**CALIFORNIA REGIONAL WATER QUALITY CONTROL BOARD  
SAN FRANCISCO BAY REGION**

**RESPONSE TO WRITTEN COMMENTS**

**ON THE REISSUANCE OF WASTE DISCHARGE REQUIREMENTS FOR:**

GWF Power Systems, L.P.  
Nichols Road (Site V) Plant  
Pittsburg, Contra Costa County  
NPDES No. CA0029106

## Probability Plots for Nichols Road (Site V)

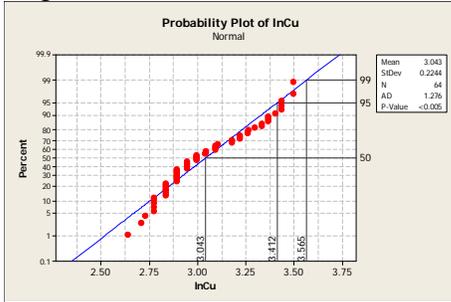
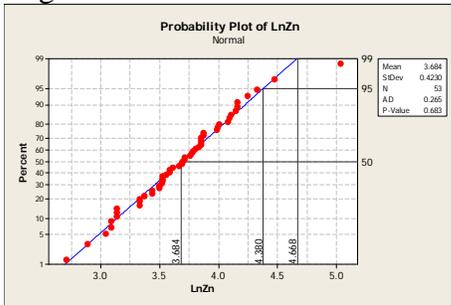
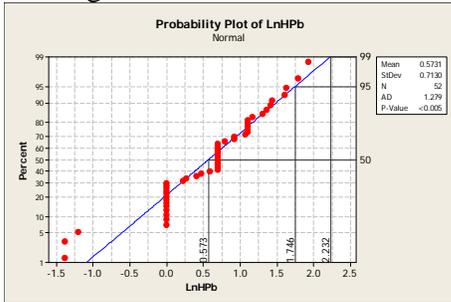
*The effluent concentration values (95<sup>th</sup> percentile, 99<sup>th</sup> percentile, and mean values) for copper, lead, zinc, and cyanide are listed incorrectly in section 4.c of the Fact Sheet. While the values utilized in the calculations of the limitations are correct, for some reason the values were not correctly documented in the Fact Sheet. GWF provided the correct values.*

We corrected the values in the Fact Sheet where needed. All values were rounded to two significant figures. However, the revisions do not include all values provided by GWF. Different programs use different algorithms to calculate the percentiles of a data set. The percentiles GWF listed appear to have been estimated using Excel. Excel uses the maximum value in the data set as the 100<sup>th</sup> percentile, and interpolates the other percentiles from that value. This is not an appropriate method to calculate percentiles because the results can never be higher than the maximum value. Therefore, we used the probability distribution of the lognormal data sets using Minitab, and estimated the percentiles from that distribution. Those distributions are attached to this document and the Fact Sheet.
